[Docket No. 2000–SW–51–AD; Amendment 39–11960; AD 2000–20–51]

Airworthiness Directives; Robinson Helicopter Company Model R22 Helicopters

2000-20-51 Robinson Helicopter Company:
Amendment 39-11960. Docket No. 2000-SW-51-AD.

Figure A

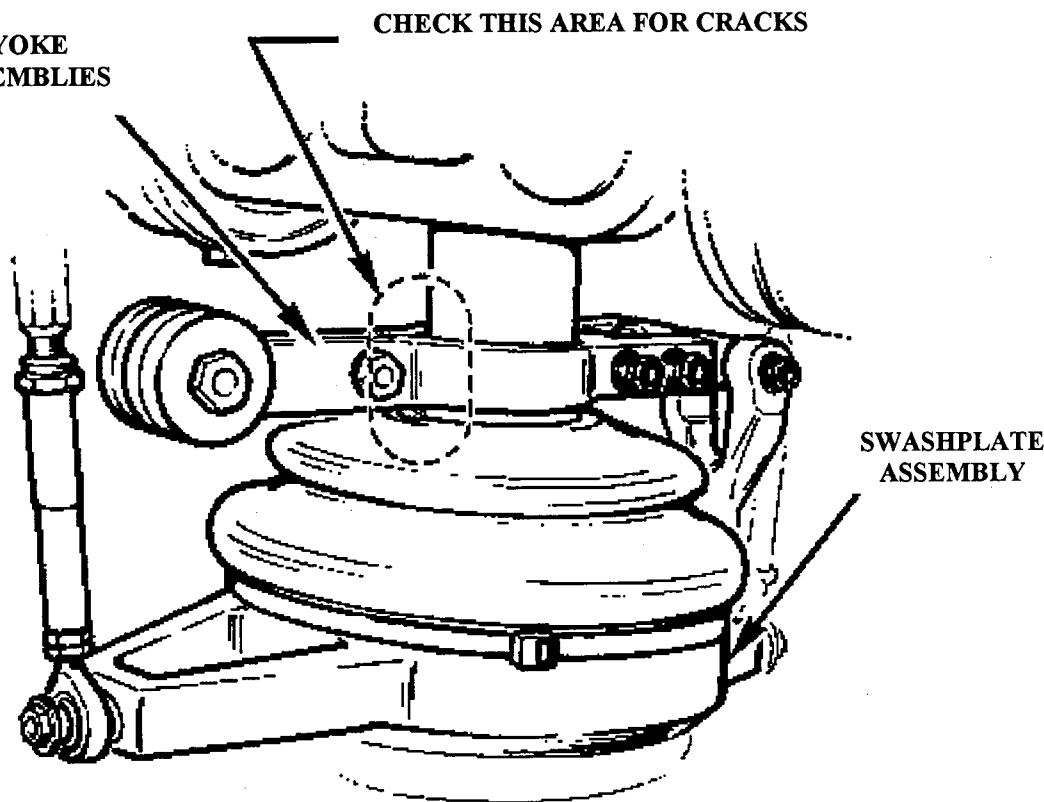
(a) Before further flight and thereafter before the first flight of each day, check each yoke for a crack. See Figure A.

(2) If the Lot identifier is from 24 through 43, if it is a letter code, or if it is illegible, replace yokes, P/N A203-5, with airworthy yokes, P/N A203-7. Yoke, P/N A203-7, cannot be installed with yoke, P/N A203-5.

(b) If a yoke is cracked, before further flight, replace the yokes with airworthy yokes, P/N A203-7. Both yokes must be replaced with yokes, P/N A203-7.
